U. S. NUCLEAR REGULATORY COMMISSION
OFFICE OF INSPECTION AND ENFORCEMENT

Report No. 81-01
Docket No. 04-01043-10 License No. IV Safeguards Group E(1-A)
Licensee: SRI International
333 Ravenswood Avenue
Menlo Park, California 94025
Facility Name: Hot Cell Facility
Inspection at: Building 131, Camp Parks Military Reservation
Inspection conducted: April 21 & 22, 1981
Inspectors: B. A. Riedlinger 5/12/81
B. A. Riedlinger, Radiation Specialist Date Signed
D. D. Skov 5/13/81
D. D. Skov, Radiation Specialist Date Signed
R. D. Thomas 5/13/81
Approved by: R. D. Thomas, Chief, Materials Radiation Protection Section Date Signed
H. E. Book 5/13/81
Approved By: H. E. Book, Chief, Radiological Safety Branch Date Signed

Summary:

Figure 3
 Locations of wipes
 and direct readings
 taken on 4-21-31/15

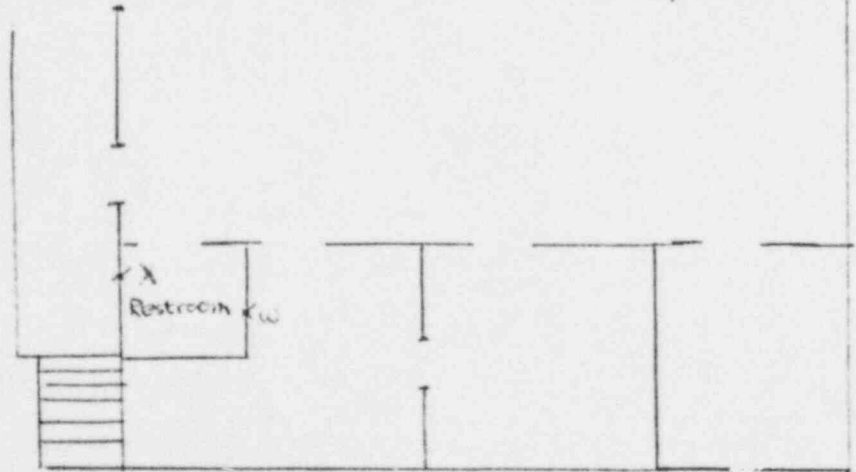
The room was surveyed with a GM pancake probe. Two spots indicated on Figure 3 showed readings above background level (W:300 cpm, and X:200 cpm). Results are given in Attachment 2. No wipes were taken in the restroom. The licensee was asked to resurvey the room.

The walls were thoroughly surveyed with GM pancake probes, and nine wipes were taken in this area. The locations of the wipes and of several direct readings are shown in Figure 3. Results are tabulated in Attachment 2. The maximum direct radiation reading was 25,900 cpm. The maximum removable contamination was 7,718 dpm per 100 square centimeters. Several locations were noted where the release limits in Tables I and II were exceeded.

The porch was surveyed with GM pancake probes, and five wipes were taken. The locations of the wipes and of several direct readings are shown in Figure 3. Results are tabulated in Attachment 2. The maximum direct radiation reading was 19,900 cpm. The maximum removable contamination was 23 dpm per 100 square centimeters. Several locations were noted where the release limits in Table II were exceeded.

As part of the survey at Building 131, Camp Parks, the roof of the facility, a concrete pad at the south end of the facility, and areas under the porch were surveyed. Three areas where direct readings were recorded are indicated on Figure 3. Results are indicated on Attachment 2. No wipes were taken in these areas.

Results of the roof survey indicated that one area of approximately one square meter yielded direct radiation readings of 1,000 cpm.

It should also be noted that a survey in the crawl space under the northwest corner of the porch indicated direct readings 150 cpm above normal background.

Based upon the direct survey readings of the roof and crawl space areas, it appears that the requirements of the established NRC guidelines (as indicated in Table II) have not been met.

The licensee was informed that the former Hot Cell Area, the porch, an area of the roof, and an area under the porch, did not appear to meet the limitations of the established NRC guidelines. The licensee should conduct a survey of the concerned areas, perform necessary decontamination, conduct a final survey and submit a written report of the decontamination and final survey to the NRC for evaluation. The licensee was also asked to include the restroom in the resurvey and decontamination effort. The licensee representatives were informed that the NRC Region V confirmatory survey would not be continued until their written report had been received.

Figure 4
 Locations of Wipes
 and direct readings
 taken on 4-22-81
 Hot Cell Facility
 Bldg. 131
 Camp Parks

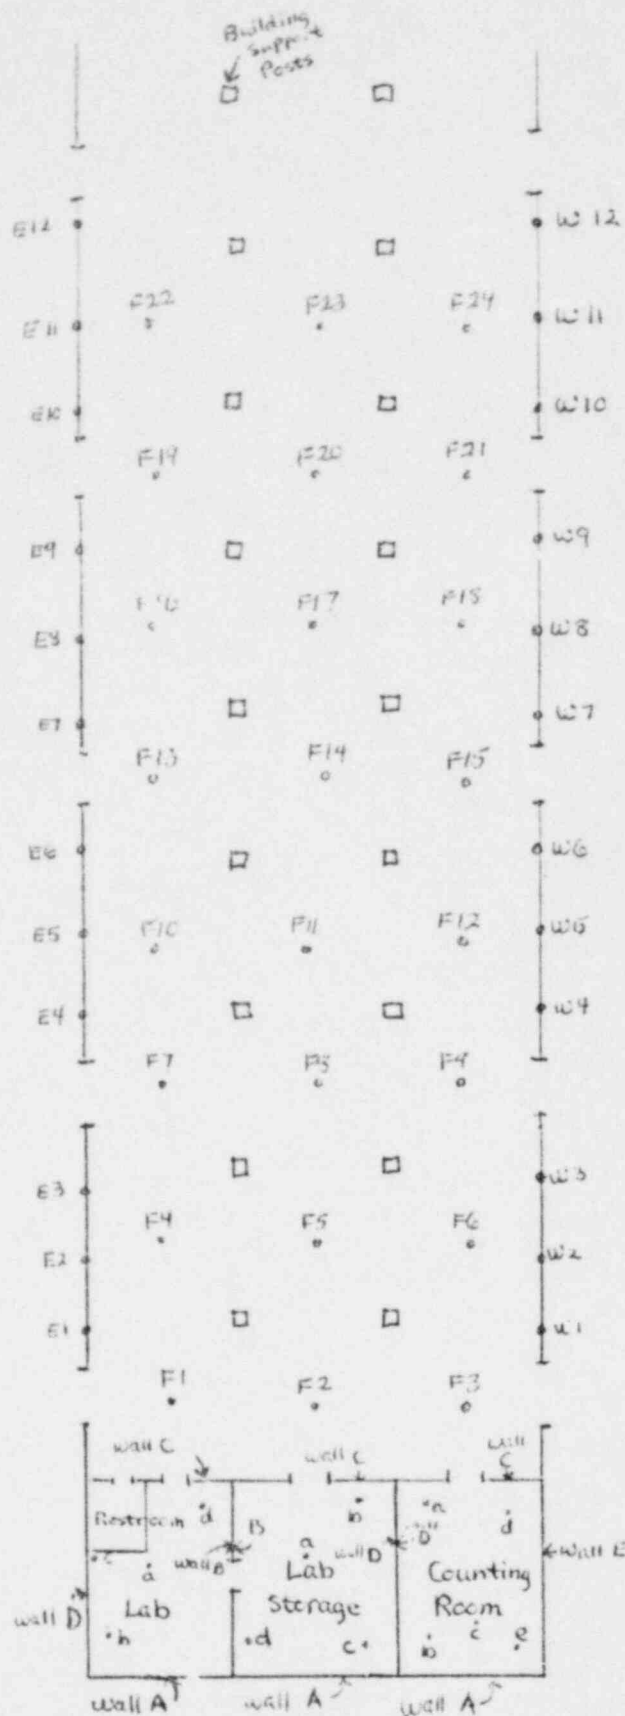
The lab was an empty room with a cart of equipment inside. Licensee representatives stated that the equipment was awaiting transfer to another controlled area. Therefore, the cart and equipment was not surveyed. There was a plugged floor drain in one corner of the room (location c on Figure 4).

The lab was surveyed with GM pancake probes. The drain plug area indicated 150 counts per minute fixed contamination. No other readings above background were observed. Eight sampling wipes were taken. The location of the areas sampled are indicated in Figure 4. The counting results, as determined by the Region V laboratory scaler, are given in Attachment 2. One wipe indicated 6 dpm per 100 square centimeters. The others indicated only background levels of radioactivity.

The walls and floors in the former waste and isotope storage areas were spot-checked with GM pancake probes. Then, direct readings with a pancake probe and wipe checks were made at the 48 locations noted on Figure 4 (wipe W6 was accidentally missed during the survey). Three other wipes were taken in this area on April 21, 1981. Their locations are noted on Figure 4. Results of the wipe counting and direct readings are displayed in Attachment 2. There were two direct readings above background. At location W7 there was 50 cpm fixed contamination, and at location W12 there was 150 cpm contamination (18 dpm removable). These meet the limits for spot contamination shown in Table II. There were six wipes which indicated removable contamination above background levels. The maximum indication was 86 dpm per 100 square centimeters. This meets the release criterion of 200 dpm per 100 square centimeters as shown on Table I.
